Modification of Development Consent

File: SSD-37486043 Mod 1

Modification 1

Oakdale East Industrial Estate
Horsley Park

Figure 1: Concept Proposal Layout

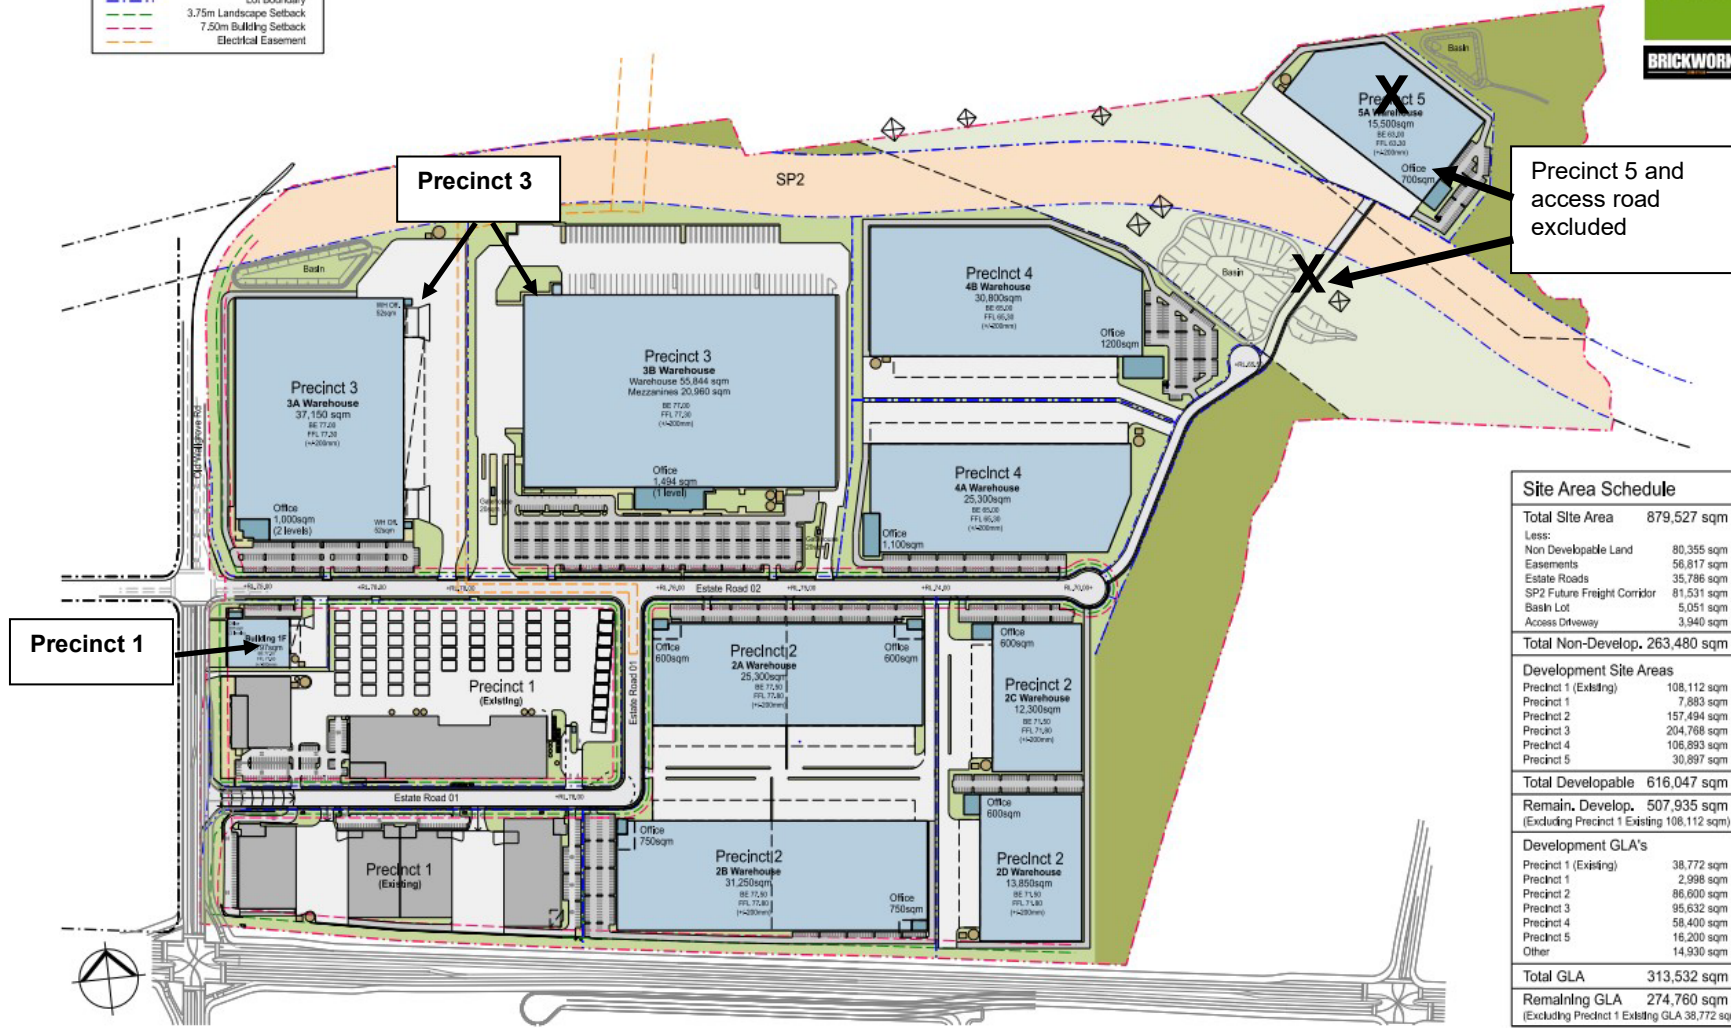
- change the warehouse layouts and number of buildings in Precincts 1 and 3
- estate subdivision layout
- gross lettable area
- increase the building height of warehouse 3B, include detailed uses and dangerous goods storage
- amend the landscape plans and add retaining walls for Precincts 1 and 3

17. In Appendix 1, replace 'Figure 1: Concept Proposal Layout' with new Figure 1 as follows:

Figure 2: Warehouse 1F Layout

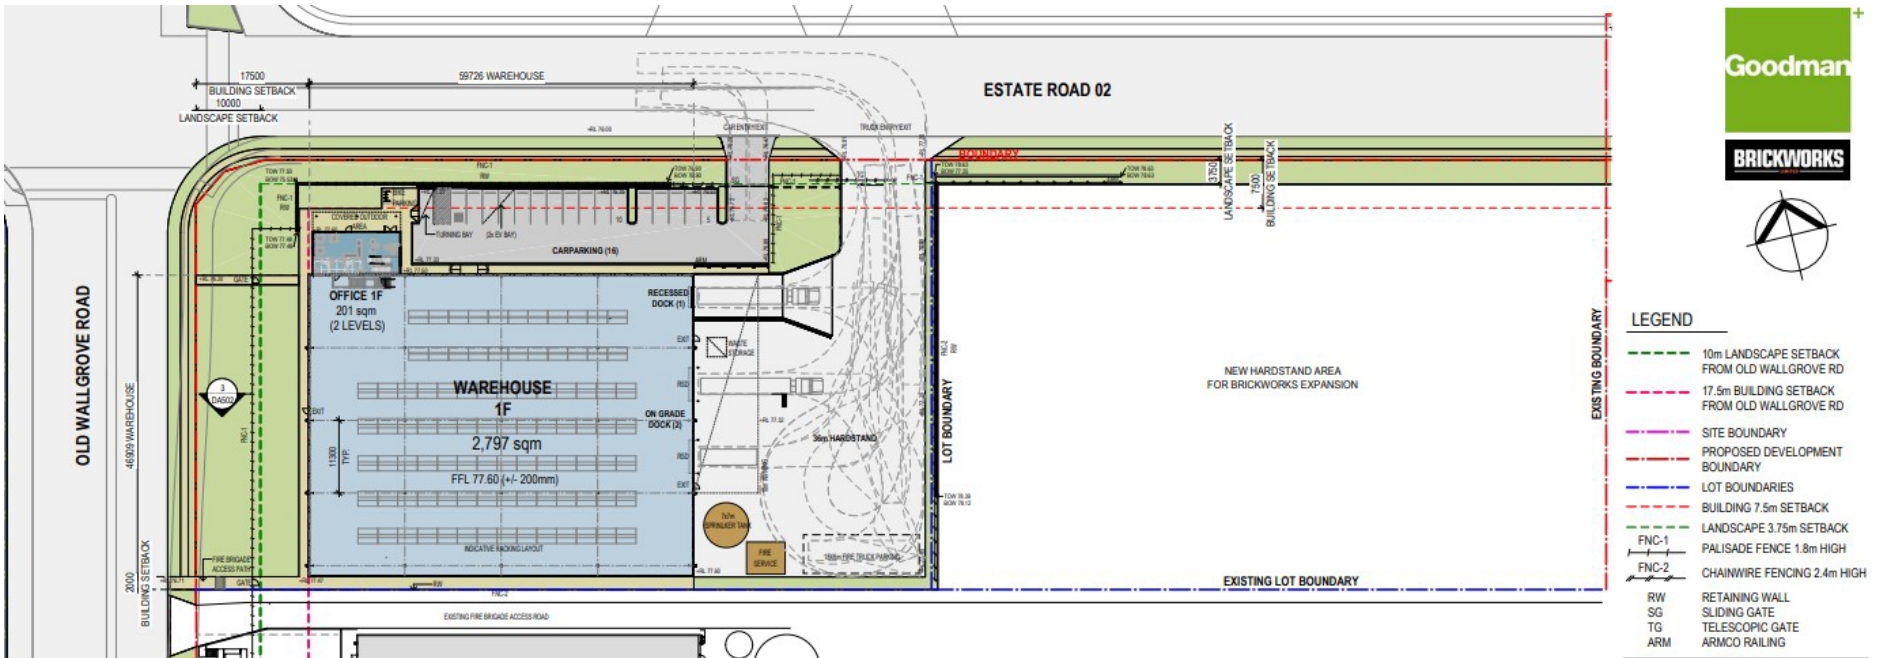
20. In Appendix 2, replace 'Figure 2: Warehouse Extension – Precinct 1' with a new 'Figure 2: Warehouse 1F Layout'

Figure 3A: Warehouse 3A Layout

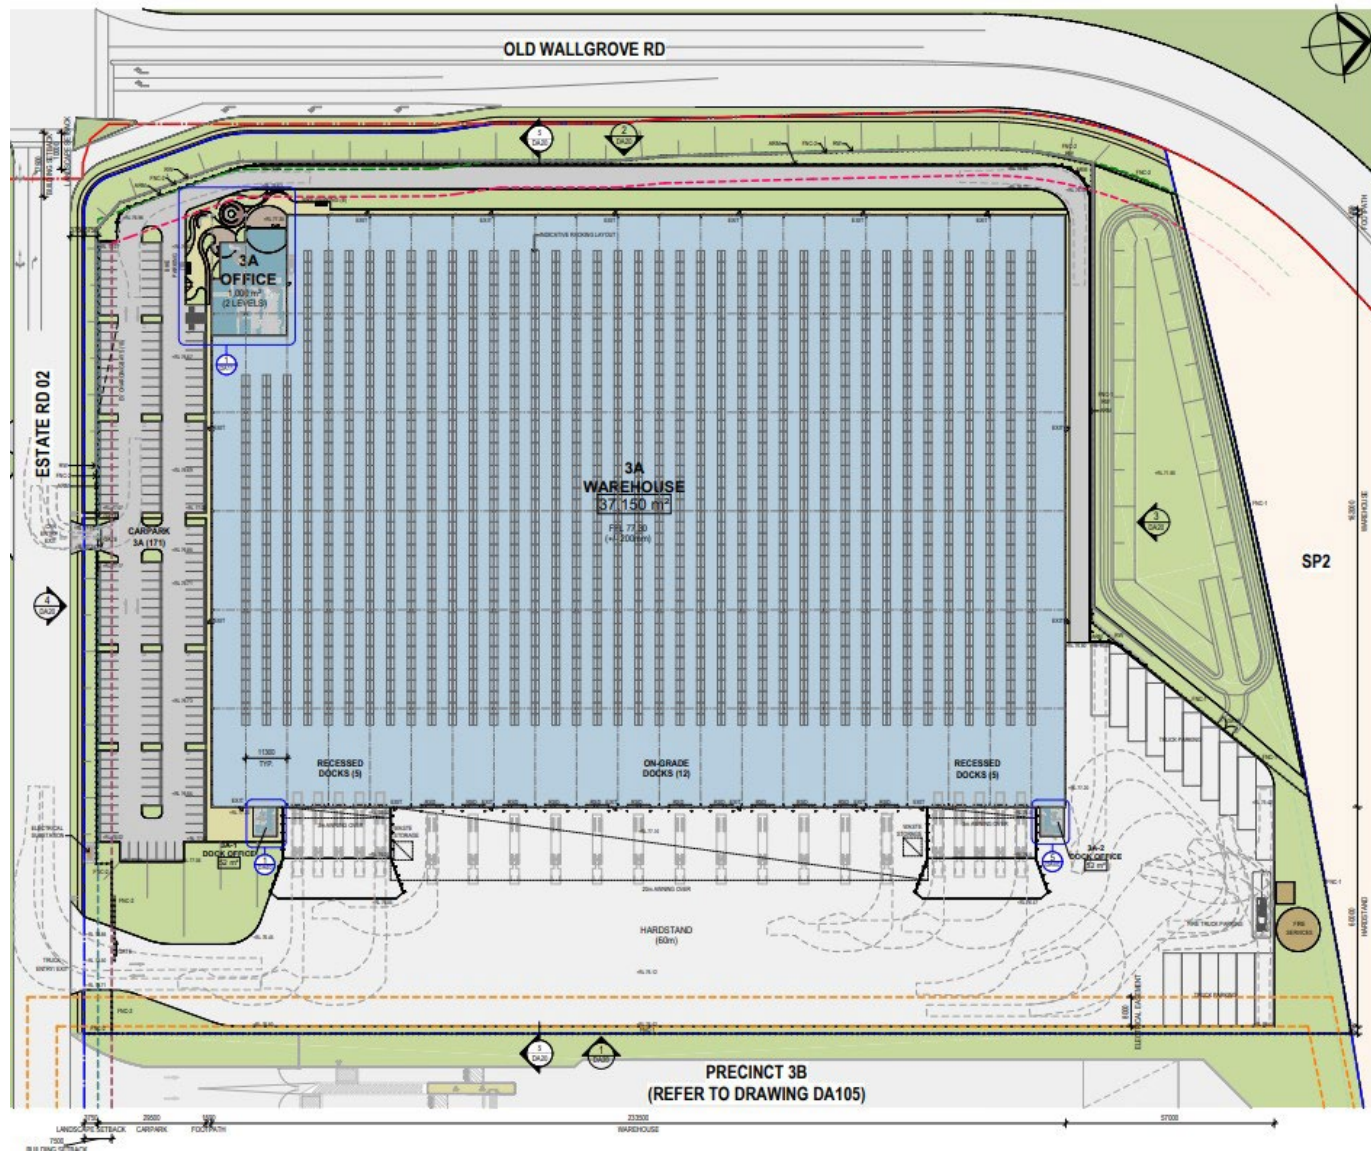
21. In Appendix 2, replace 'Figure 3: Precinct 3 Layout' with two new figures 'Figure 3A: Warehouse 3A Layout' and Figure 3B: Warehouse 3B Layout'

Figure 3B: Warehouse 3B Layout

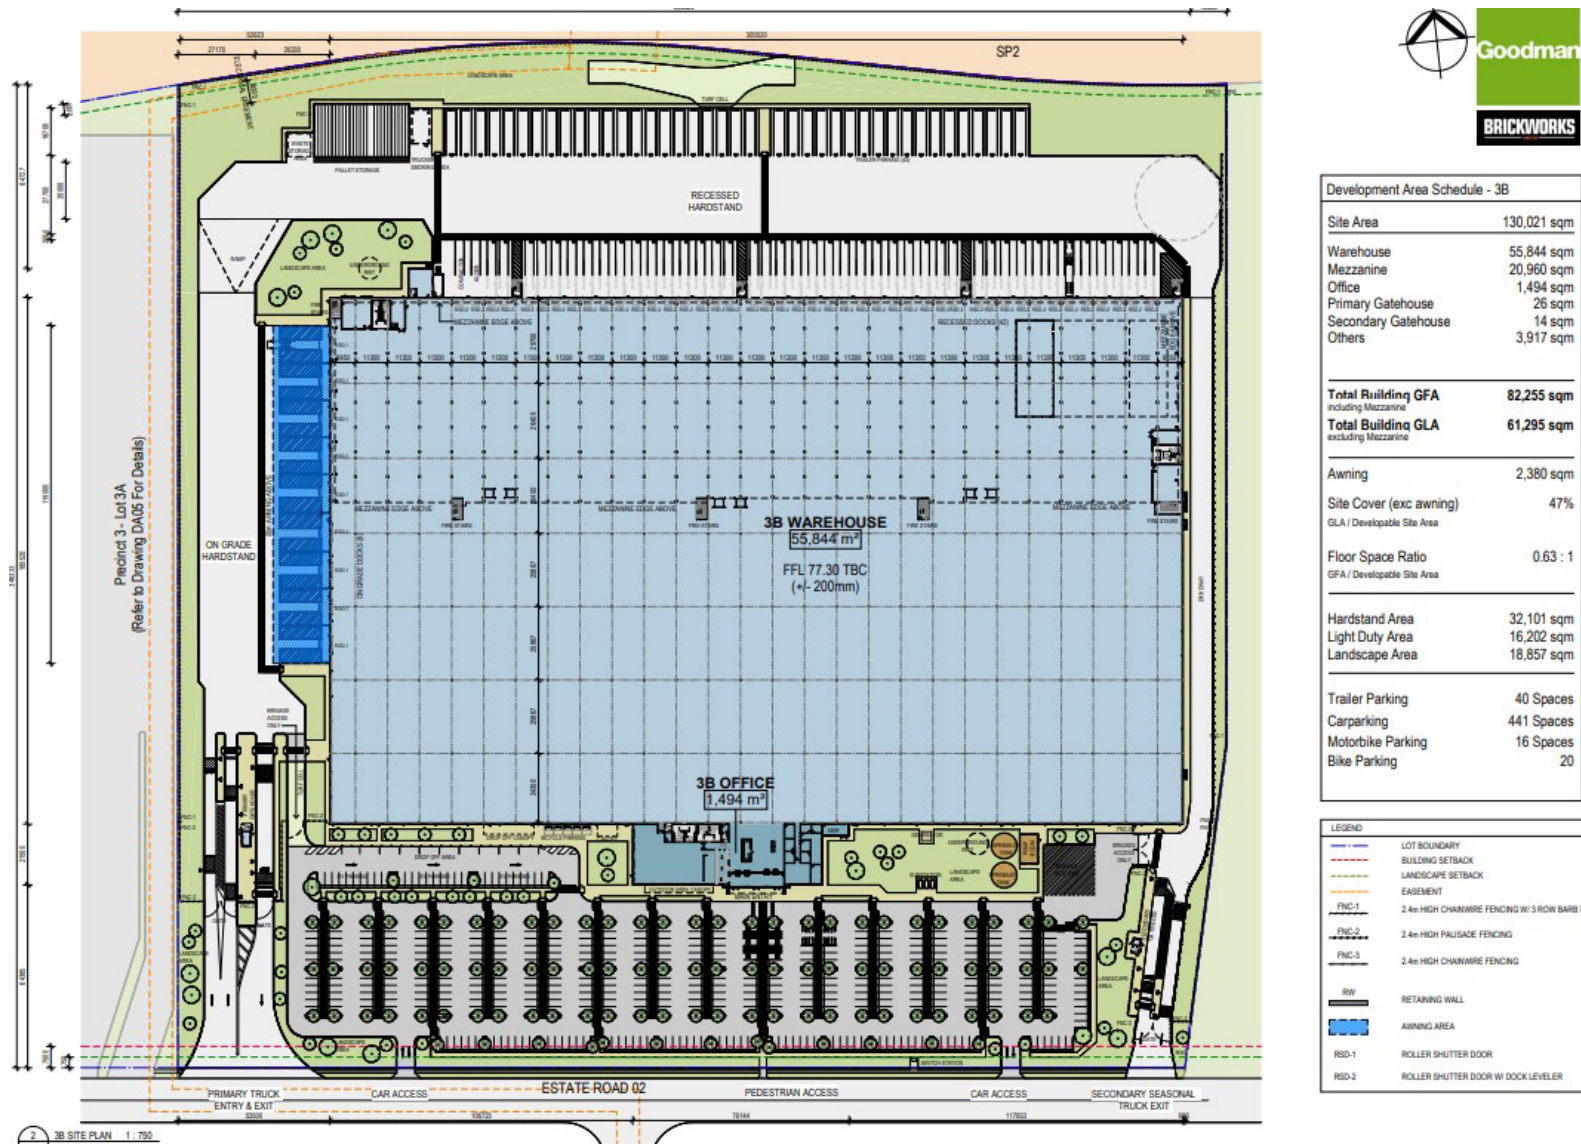
313,532
5. In condition A10, Table 2, insert a new row under 'Heights' as follows:
 - Building 3B in Precinct 3 16.8 m²
